KINROSS Gold Corporation

PROJECT ANNUAL INSPECTION OF PERIMETER TAILINGS DAMS				
TITLE				
DAM 4 INSPECTION PHOTOS				
PROJECT No.		DWG. No.	REV.	
0256-009-02		10	0

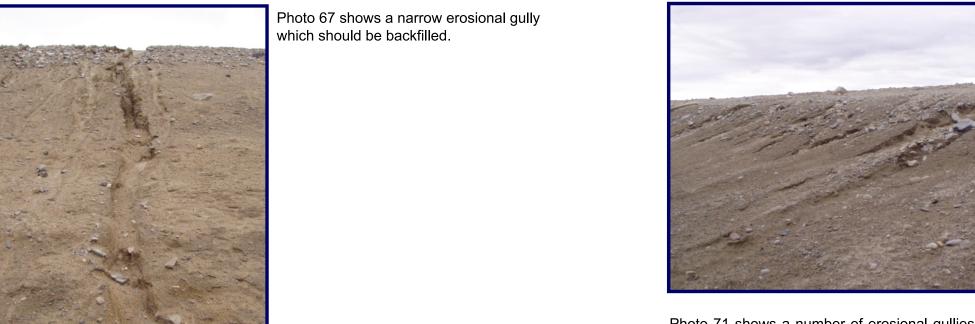
Photo 60 shows a significant windrow which has been formed on the crest of Dam 4 at its west abutment. This crest will have to be regraded to a proper grade to prevent future erosion.

Photo 68 shows four erosional gullies which should be backfilled.

Photo 71 shows a number of erosional gullies right at the west abutment on the downstream side. These should be backfilled to prevent any additional erosion.
